Meeting: 4/15/2026
Applicant: Jesse Alarcon Onyx Excavation LLC
Owner: Jesse Alarcon Onyx Excavation LLC
District: Oakwood/Lincoln Park Infill Housing Overlay District

Location: 205 Chickamauga Ave. **Parcel ID:** 81 B G 039
Zoning: RN-2 (Single-Family Residential Neighborhood)
Description: New primary structure (duplex)

8-B-25-IH
APPLICATION FOR CERTIFICATE OF APPROPRIATENESS

205 Chickamauga Ave.
Oakwood/Lincoln Park Infill Housing Overlay
District

PLOT PLAN
1" = 10'-0"

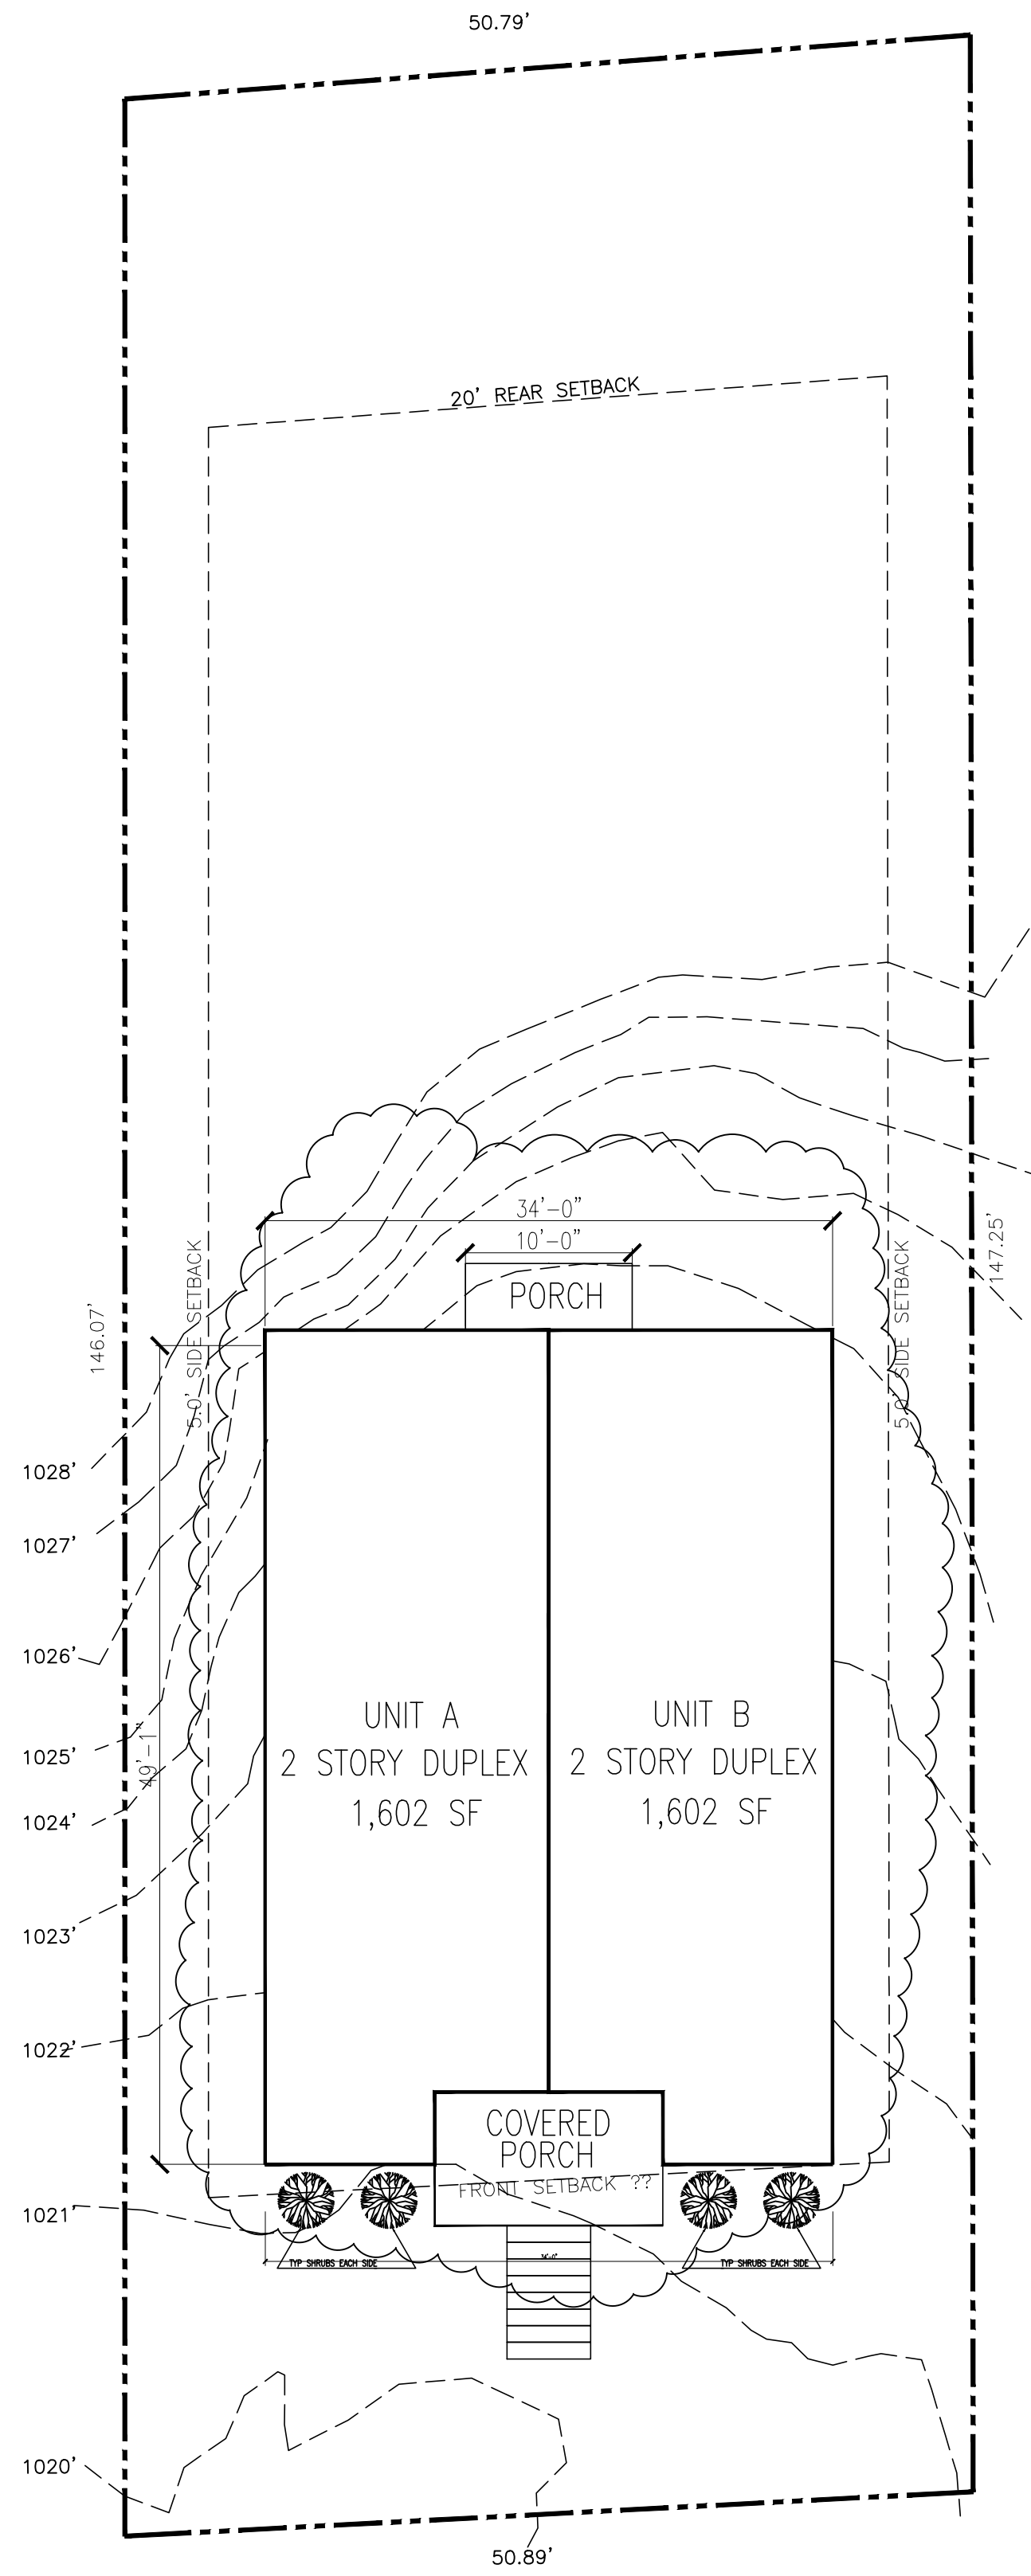
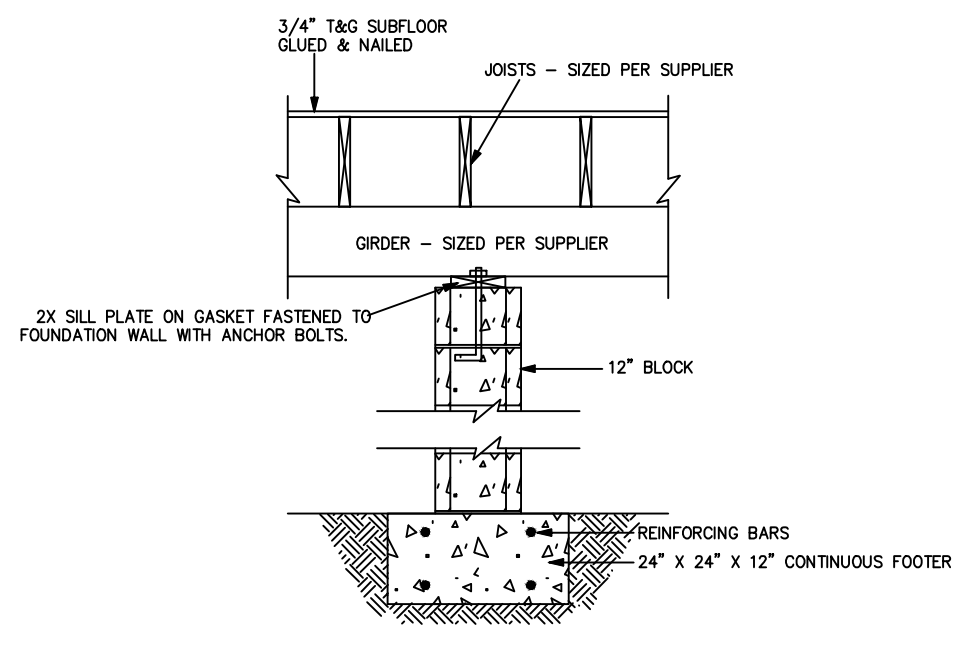
Front Yards: The 21.4' front setback is the minimum allowed by Middle Housing standards, and the porch and steps will project 8' into the front setback. The adjacent one-story houses are set 12' and 27' from the front lot line, with the porches at appx. 8.6' and 19'. Increasing the front setback would likely result in a taller foundation.

House Orientation and Side Yards: The 50' deep building is deeper than most buildings on the block, and the side elevations are large in scale. The proposed subdivision plat meets the guidelines.

A3.1

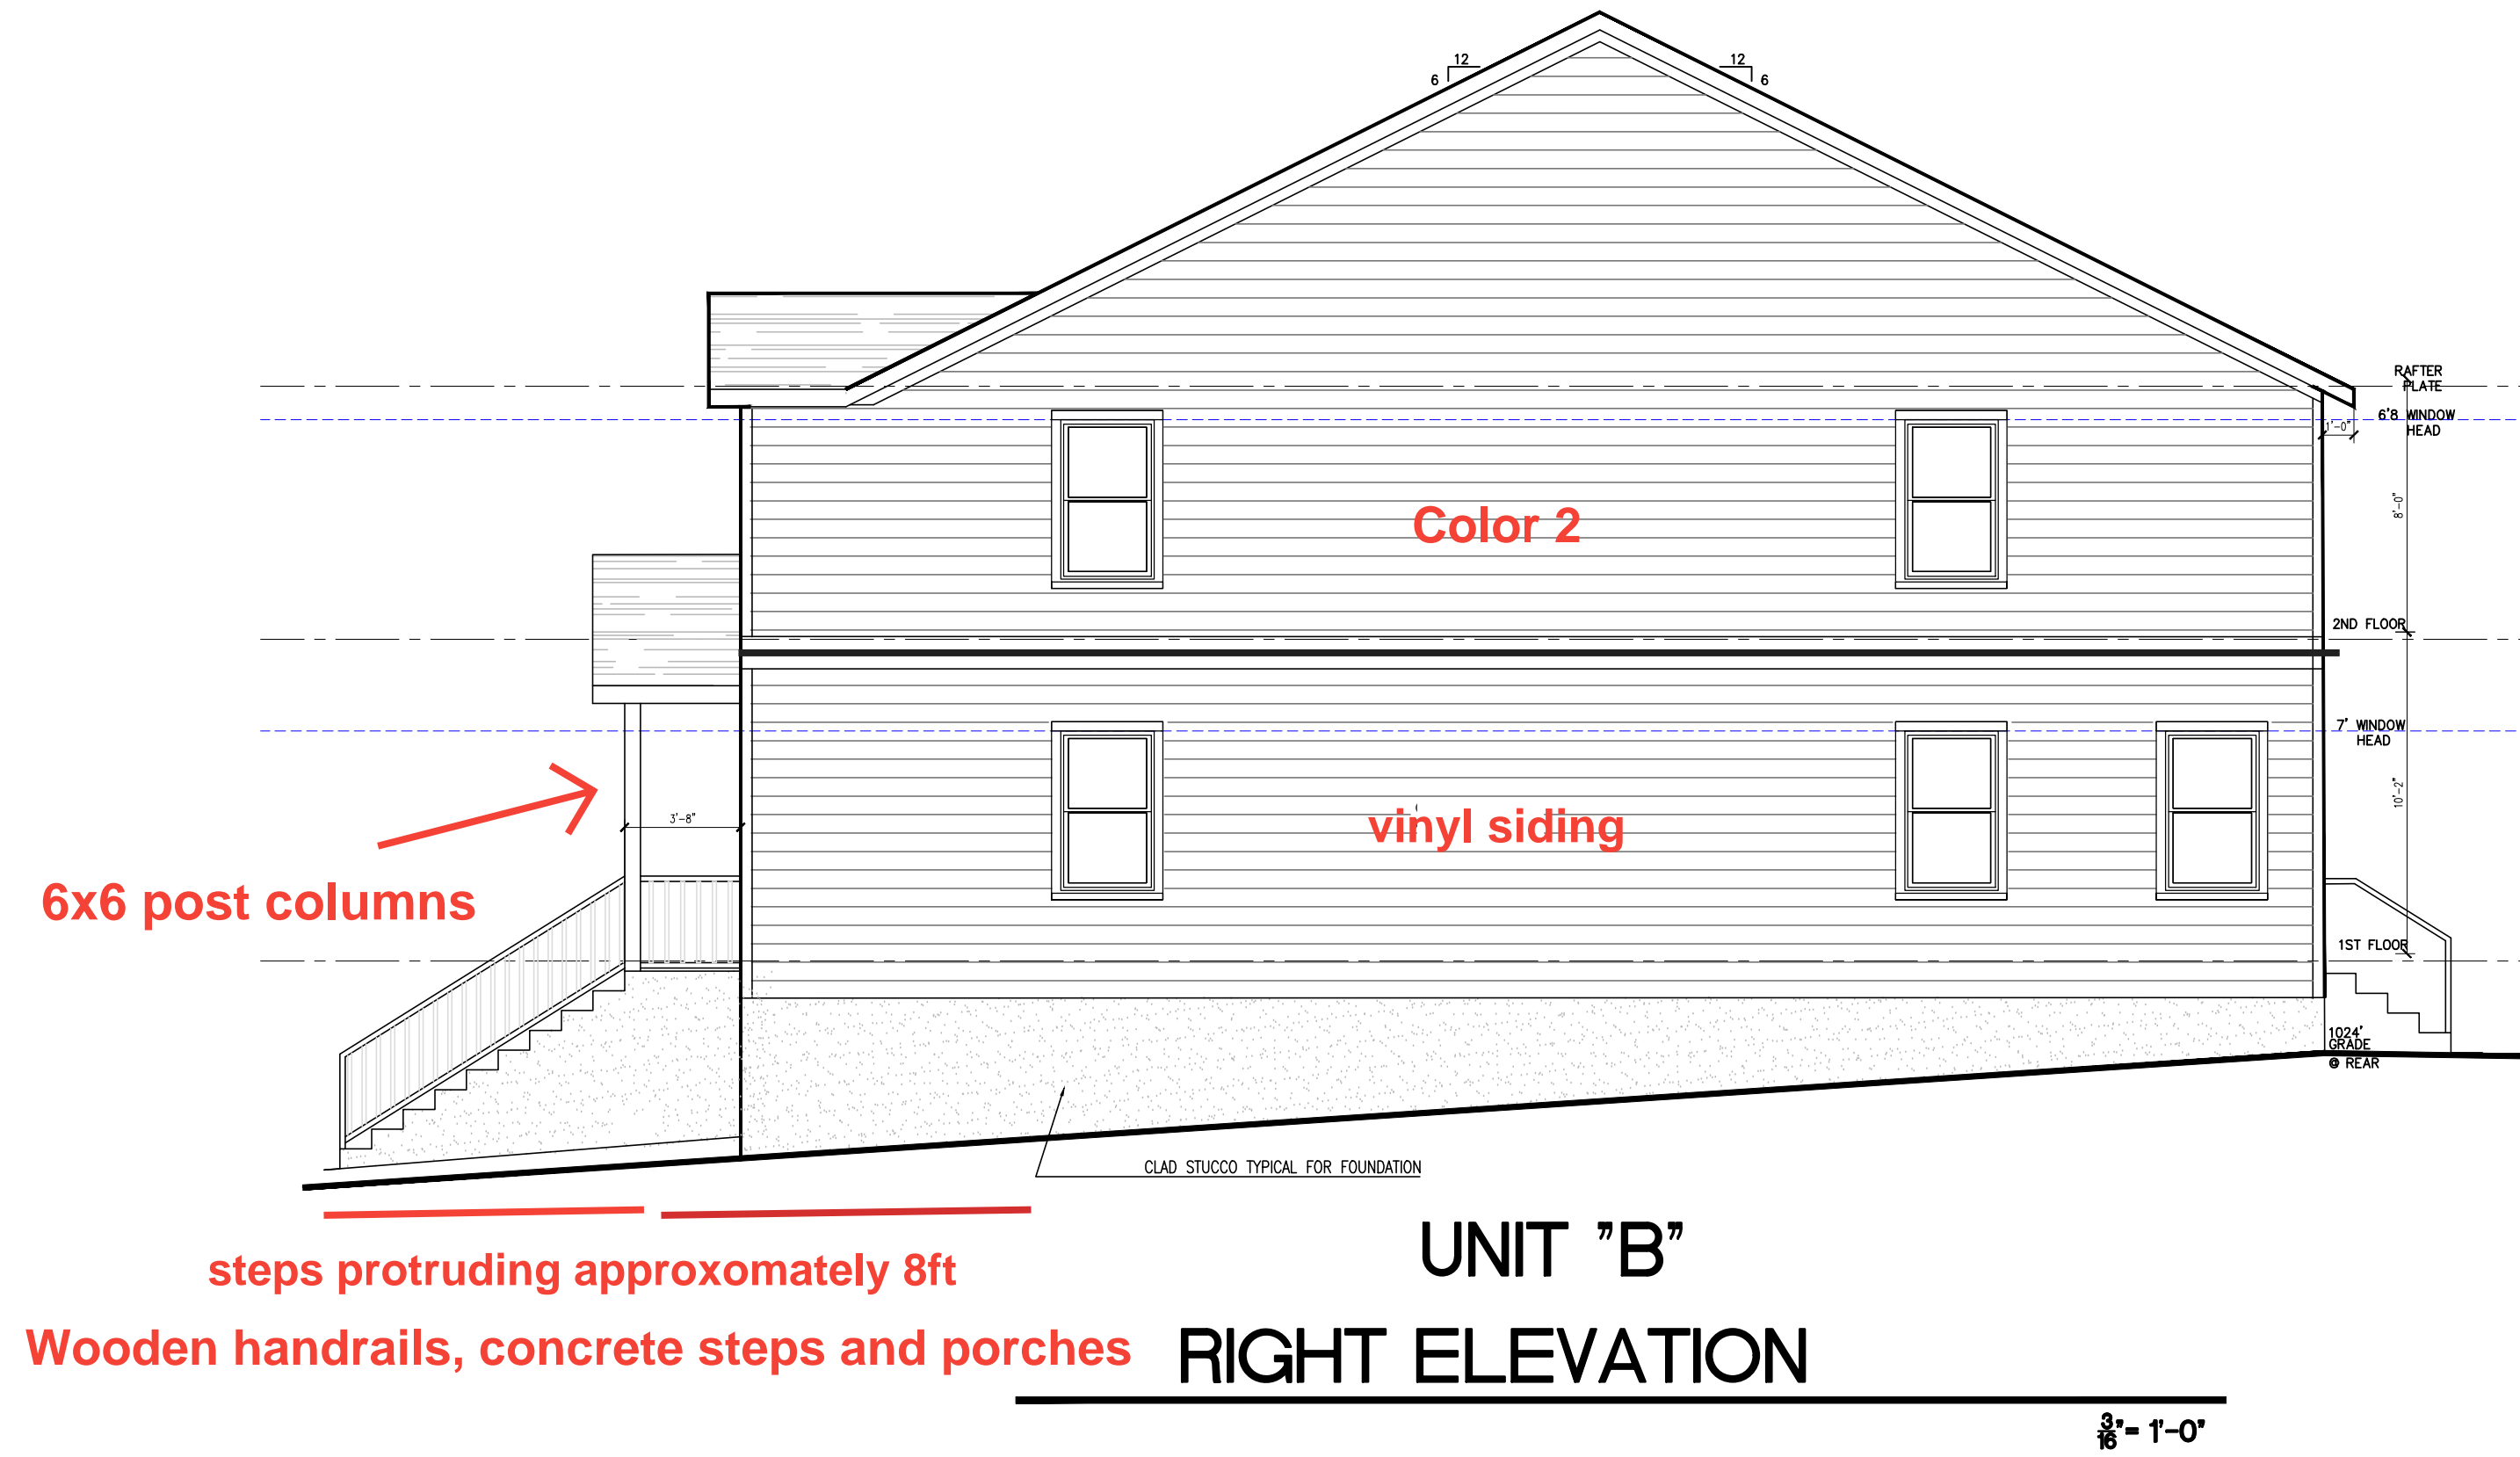
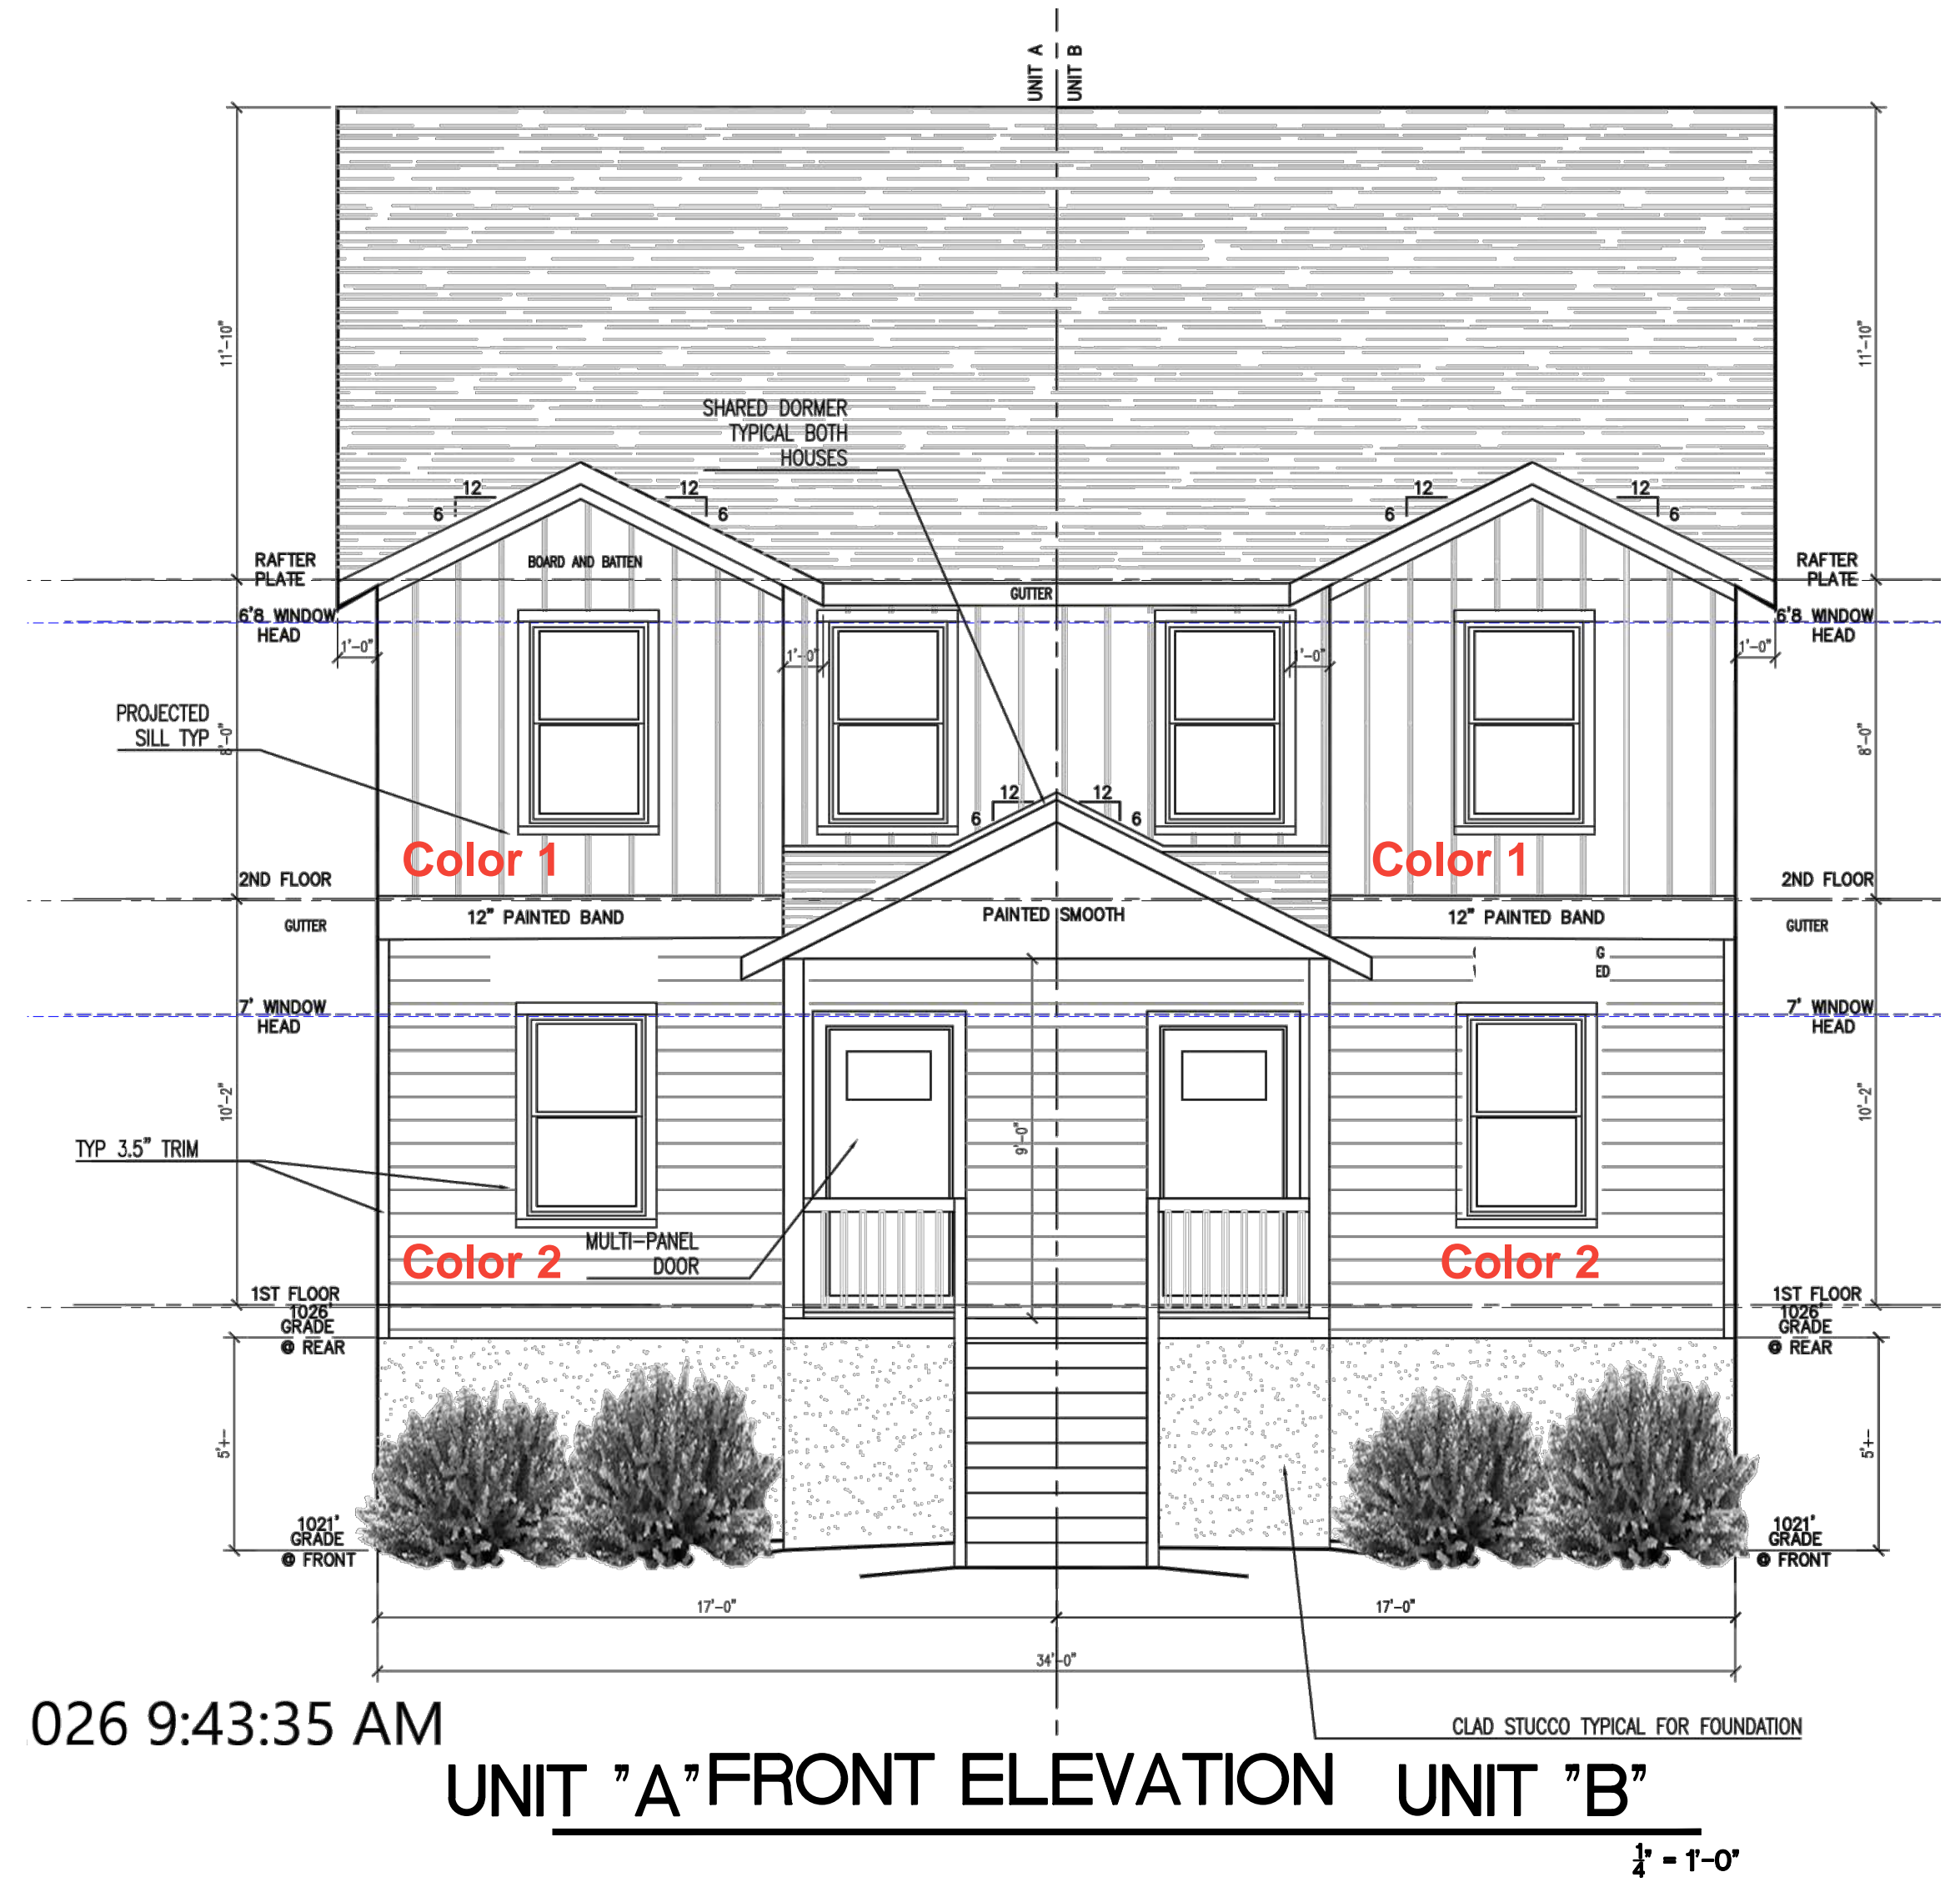
Scale, Mass, and Foundation Height: The block is characterized by one-story Minimal Traditionals, modified Queen Anne cottages, with one two-story townhouse building. The visual scale of the two-story building is increased by the 5' tall foundation height, but it is broken up by the projecting front porch and steps.

Porches and Stoops: Appropriate. The design benefits from the stuccoed concrete porch steps and flooring.

Siding Materials: Appropriate. The applicant is proposing an identical duplex on the adjacent eastern property, which will be differentiated by siding colors. Additional measures could be taken to differentiate the two buildings.

Multi-Unit Housing: The shared front porch breaks and trim dividing the stories breaks the massing into smaller sections.
